**KAHLE WATER QUALITY BASIN IMPLEMENTATION PROJECT
STATELINE, NEVADA**

Nevada Tahoe Conservation District
400 Dorla Ct., PO Box 915
Zephyr Cove, Nevada 89448
(775) 586-1610

ITEM 2: Replace plan sheets C-3, C-4, C-5, and C-6 dated March and February 2018, respectively, with plan sheets C-3, C-4, C-5, and C-6 dated April 2018 and provided in this addendum. The revised plan sheets contain the following changes:

ADDENDUM NO. 1, Page 2 of 2

SHEET
C-3
7 OF 17

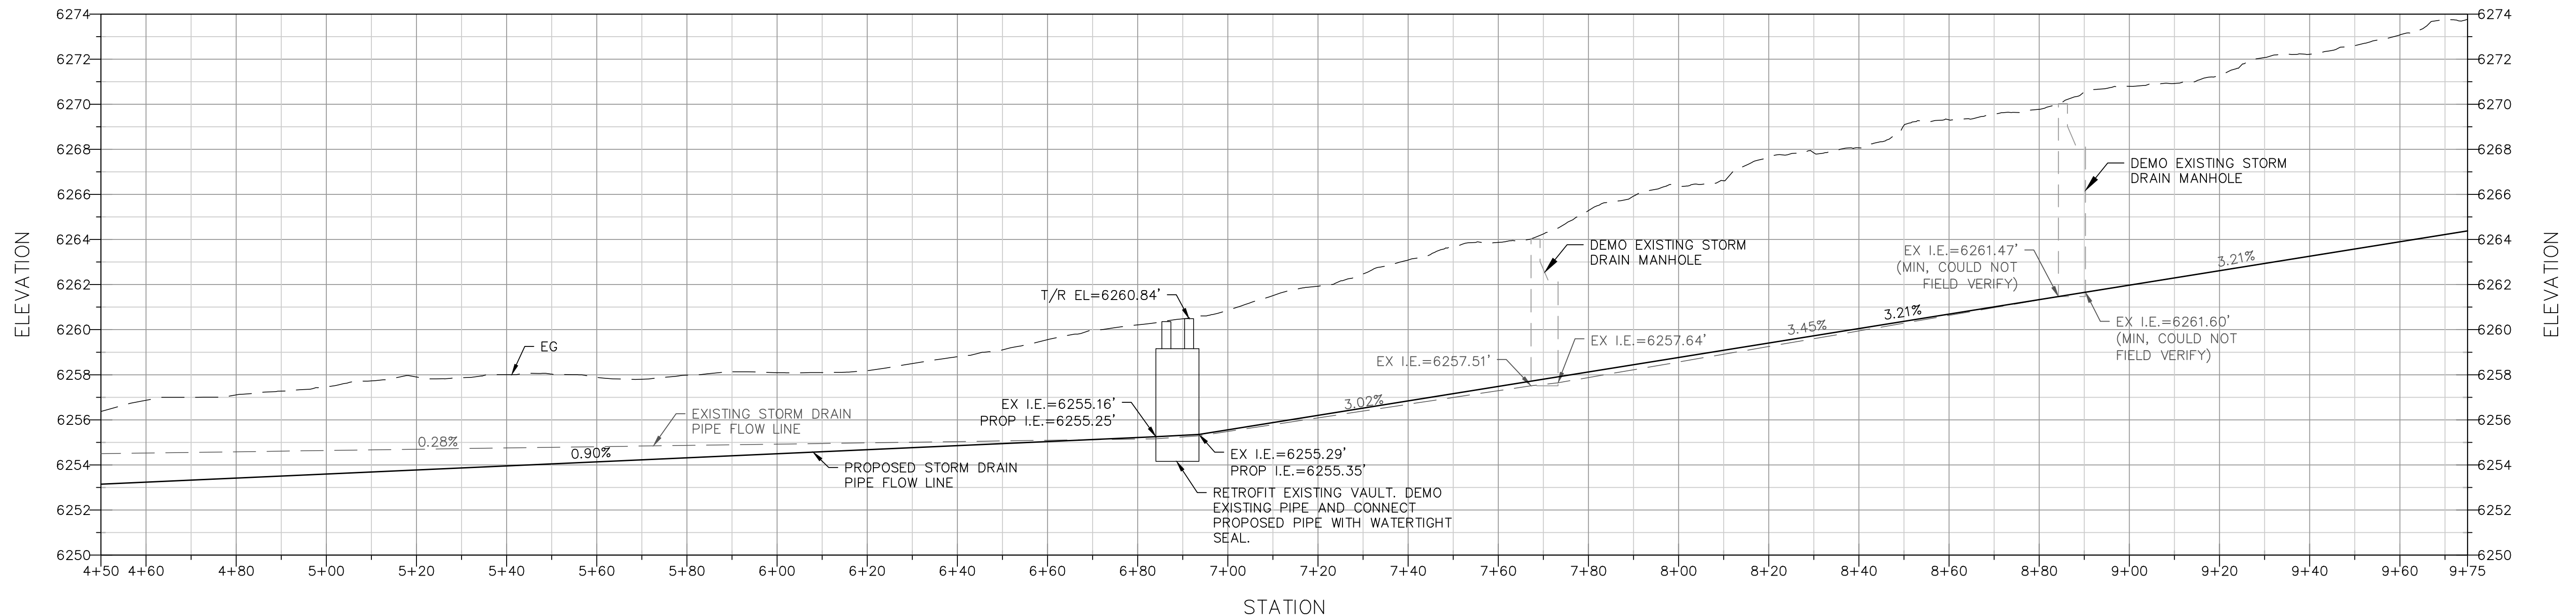
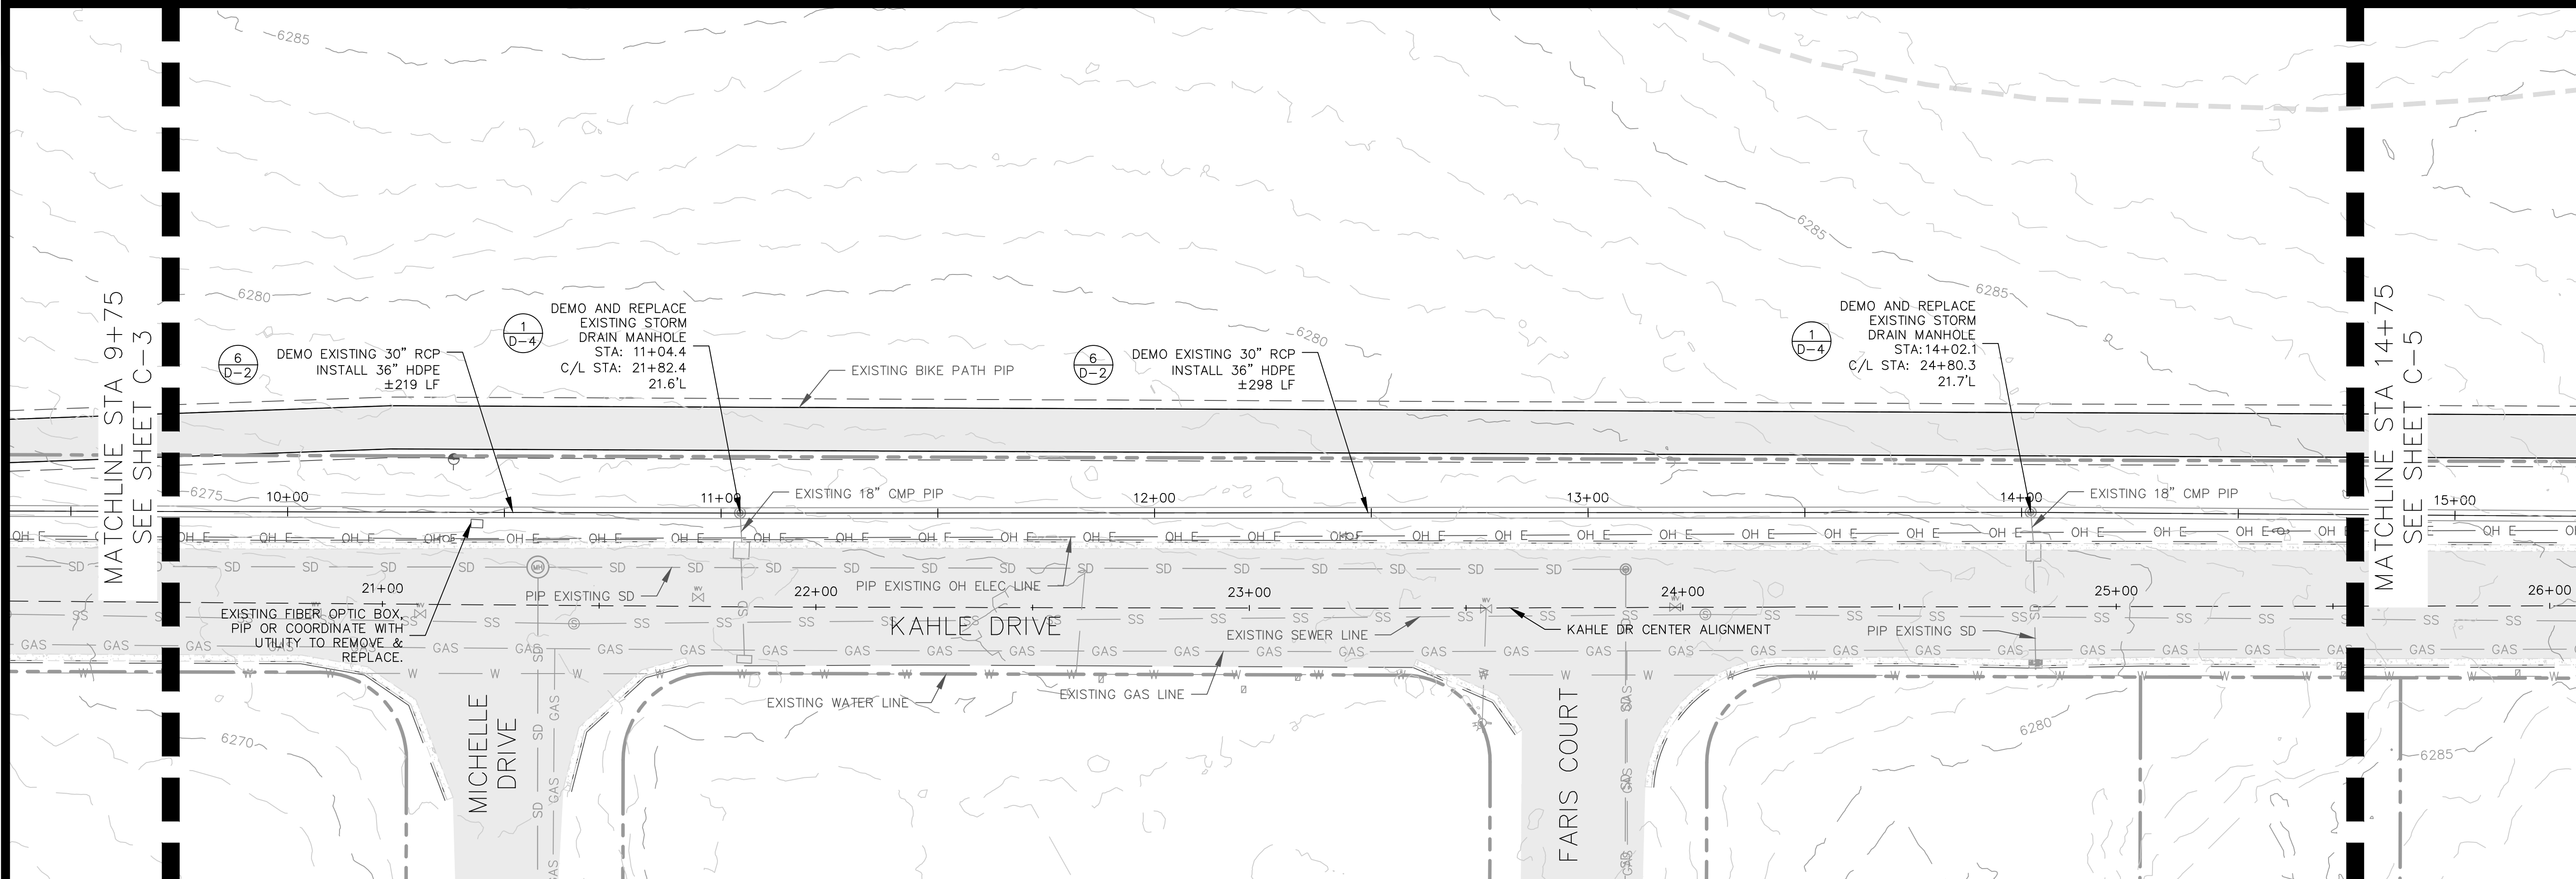
1. The slope of the flow line of the existing and proposed storm drain has been changed between stations 6+91.4 and stations 18+54.1 (C-3, C-4, and C-5).

2. The manhole depth and invert elevations have changed at three manholes located at stations 8+85.2, 11+04.4 and 15+86.8 (C-3, C-4, and C-5).
3. An existing fiber optic box is called out to protect in place or coordinate with utility to remove and replace. This was previously identified as an electrical box. This work shall be considered as part of the lump sum cost for bid item 13 (C-4).

SHEET
C-5

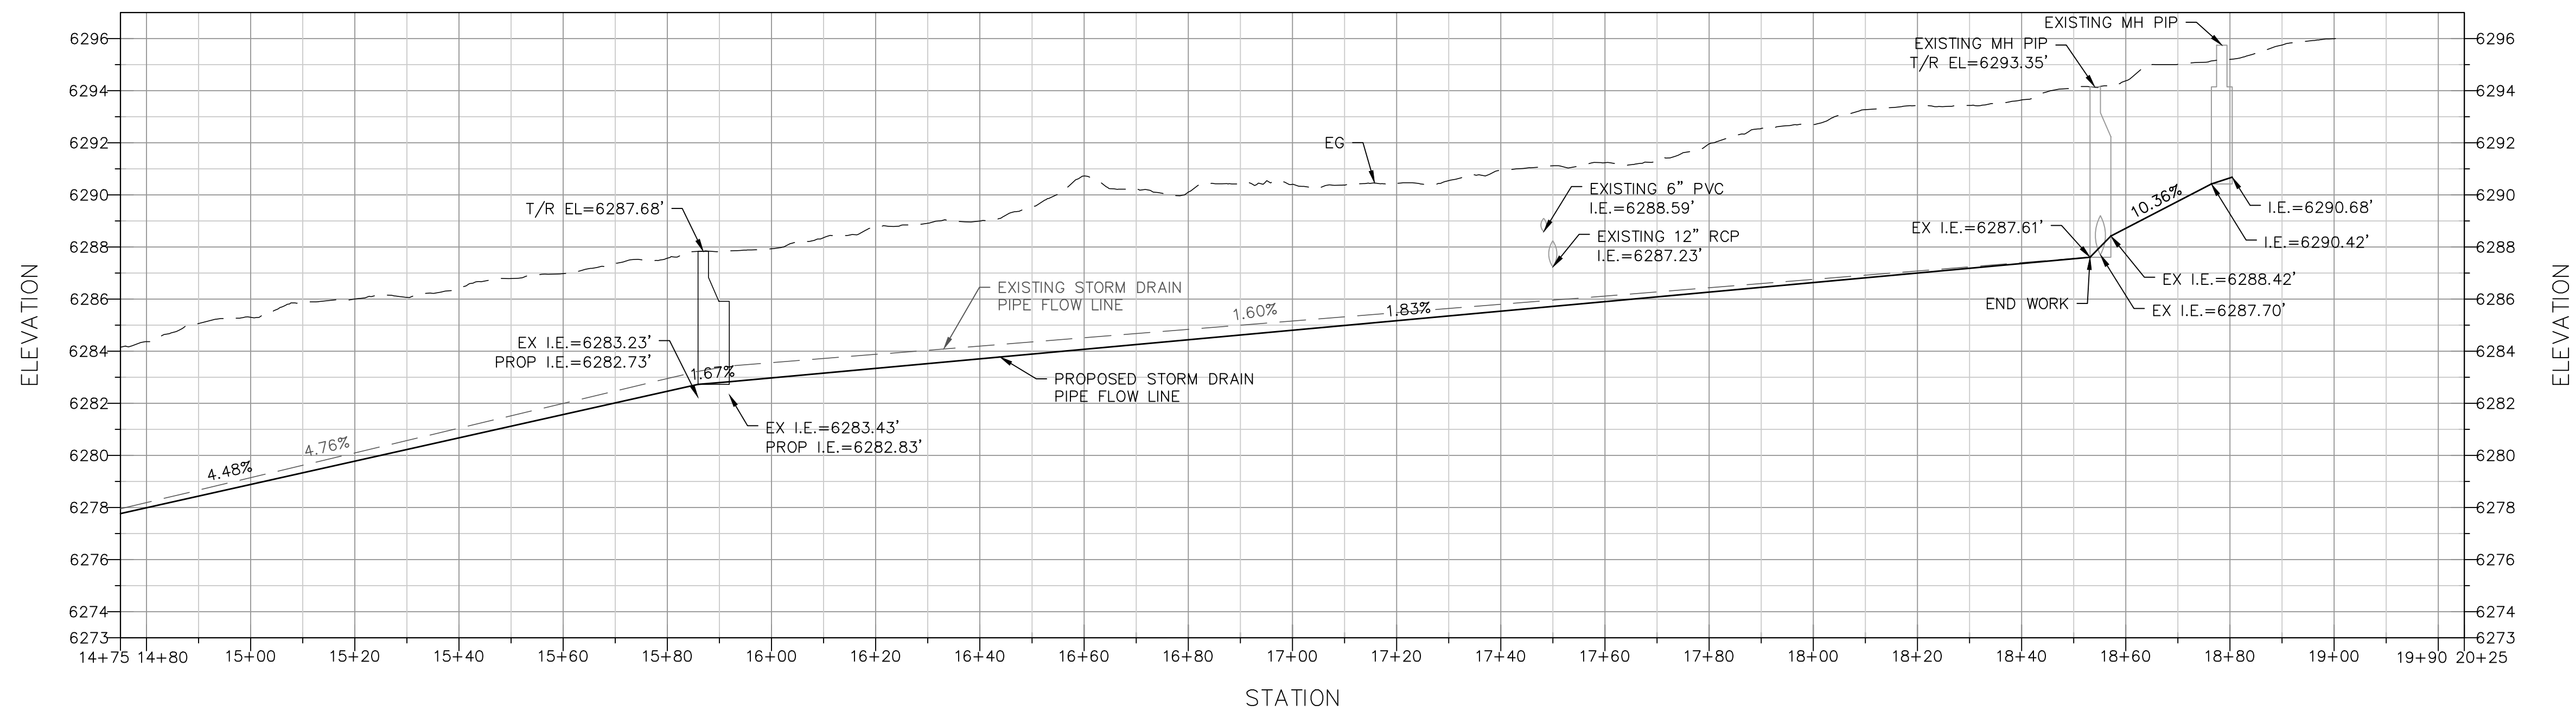
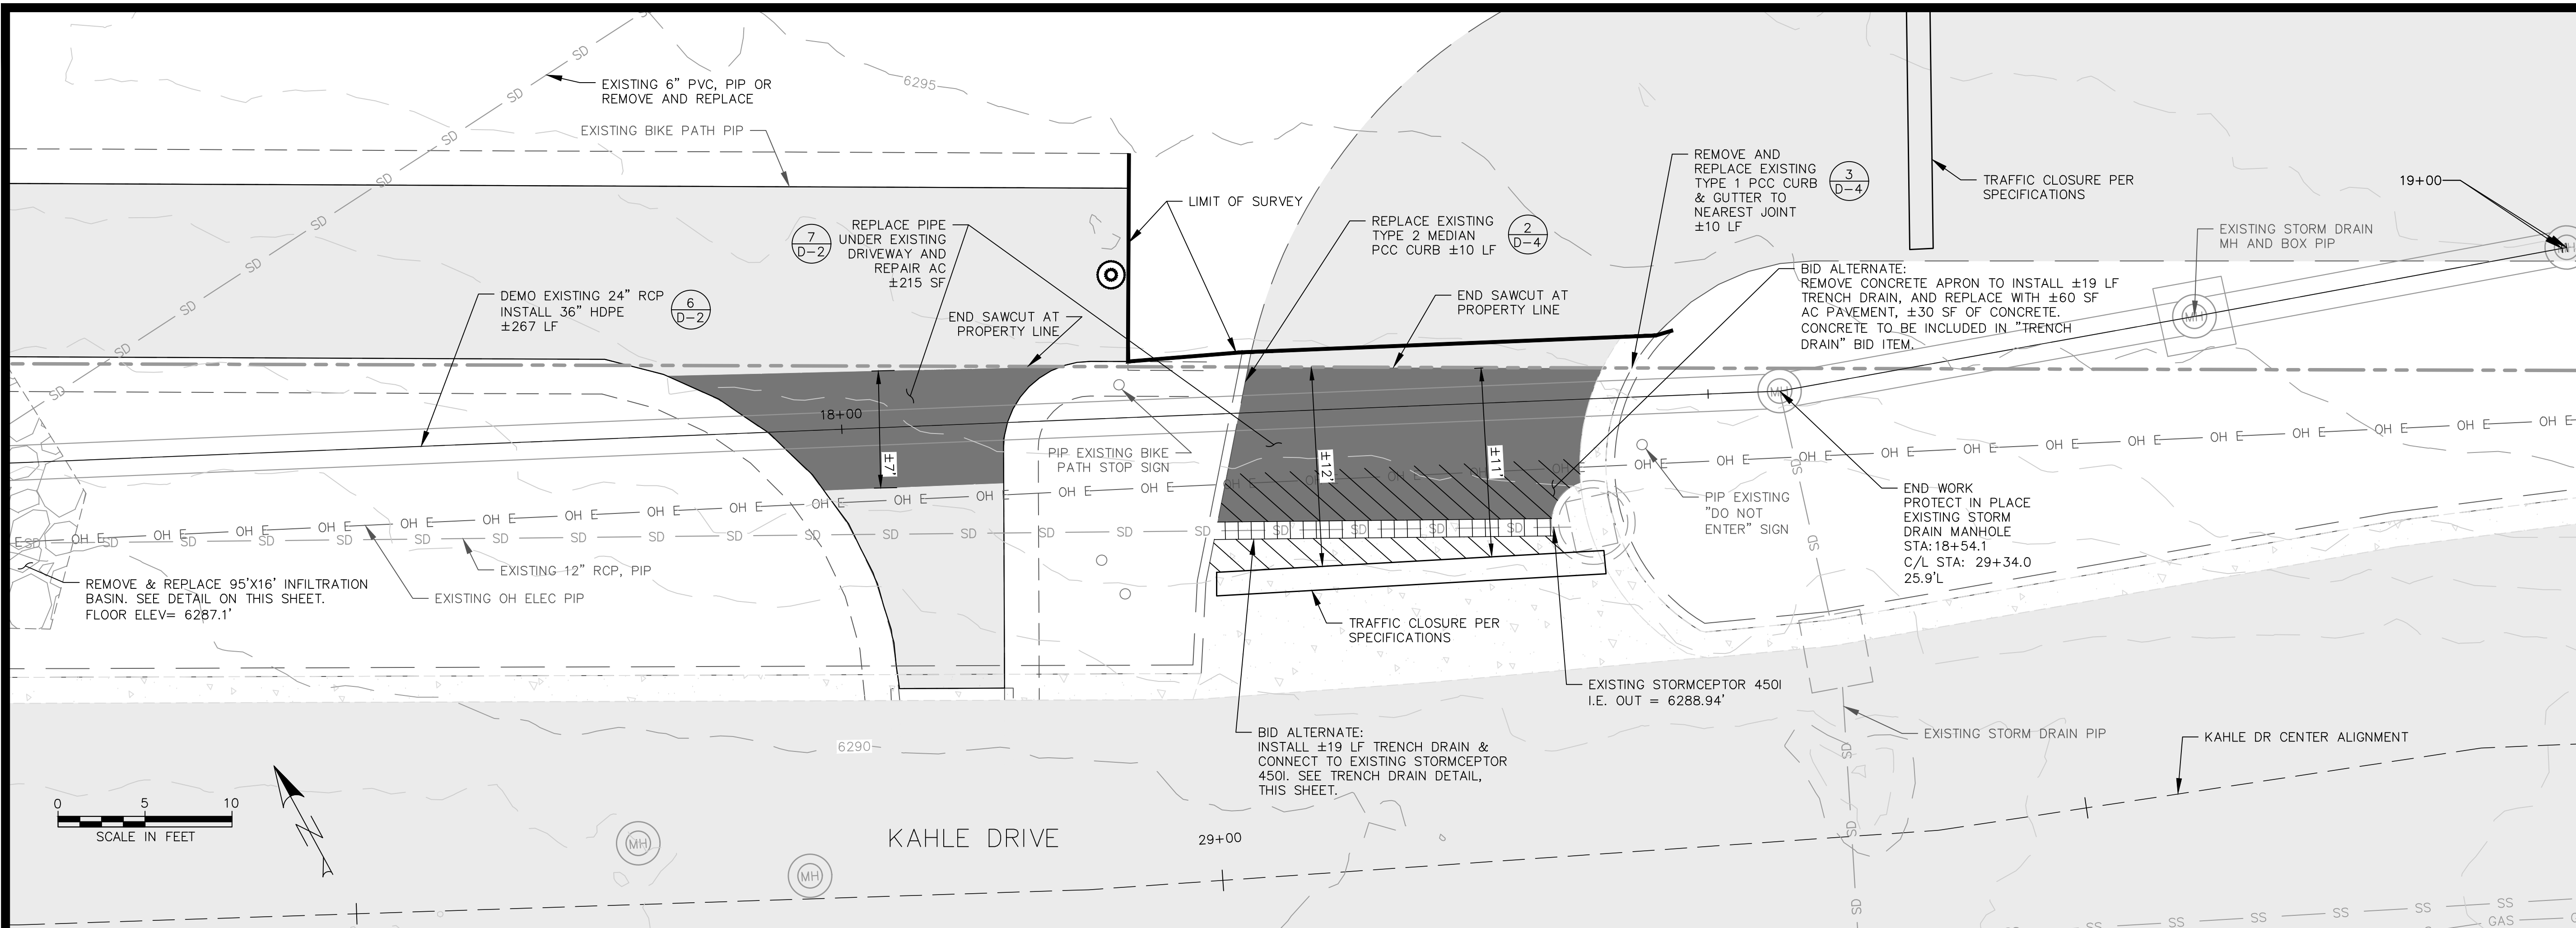
4. An existing concrete slurry cutoff wall has been called out for demolition. This work shall be considered as part of the lump sum cost for bid item 14 (C-5).

5. An existing rock basin is shown on the plans. Additional detail has been added on removal and replacement of the existing basin over the storm drain pipe alignment. This work shall be considered as part of the linear foot unit cost for bid item 21 (C-5 and C-6).

6. Additional detail is added for the inlets of the existing rock basin in plan and profile (C-5 and C-6).
7. A ±19 linear foot trench drain is called out for installation and connection to the existing Stormceptor 450i drainage inlet. This is a bid alternate item.

9. Two possible locations for a ¾" irrigation connection to provide water for proposed temporary irrigation are shown on the plans (C-5). Contractors shall pay a standard rate to Kingsbury GID for the water from these locations.
